# UNITED STATES PATENT AND TRADEMARK OFFICE

APPLICATION NO.	FILING DATE	FIRST NAMED INVENTOR	ATTORNEY DOCKET NO.	CONFIRMATION NO.
10/658,447	09/08/2003	Timothy Crowley	9138-0098US	4731
32425 7590 12/06/2007 FULBRIGHT & JAWORSKI L.L.P. 600 CONGRESS AVE. SUITE 2400 AUSTIN, TX 78701				
EXAMINER MENON, KRISHNAN S				
ART UNIT 1797		PAPER NUMBER		
MAIL DATE 12/06/2007		DELIVERY MODE PAPER

**Office Action Summary**

### DETAILED ACTION

Fig. 7

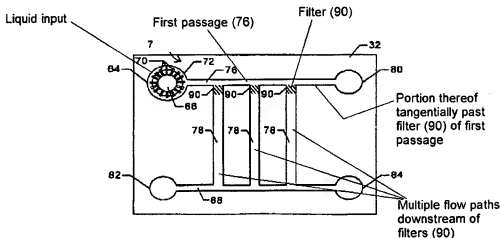
Fig 7 annotated with respect to claim 7.

Figure 7 of the reference is annotated with the elements of claim 7 to show how the claims read on the reference.

Sundberg teaches a microfluidic instrument in figure 7 comprising an input (70), a first passage (76), a tangential filter in the first passage (the first of the filter 90, which is a weir type filter – see figure 8), and multiple liquid flow paths (78) downstream of the filter as claimed – for claim 7, the second and third flow paths (78) are downstream and is tangentially past the first filter (90). For claim 81, all channels 78 are downstream, because claim 81 does not recite “tangential” structure. Figure 7 shows only three channels 78, but the abstract and column 4 lines 3-10 teaches that any number of channels 78 are possible (such as five or more). All flow paths are parallel, lead to an output (82,84), have analytical provisions (column 1 lines 10-15, column 5 lines 15-28), and have capillary action (abstract). Tangential flow as in claim 85 over filter 90.

Claim 92: covering plate – see figures 7 and 8: plan and cross-sectional elevation, showing covered structures.

Claim 102, 105: multiple receiving means – see 70, figure 7.
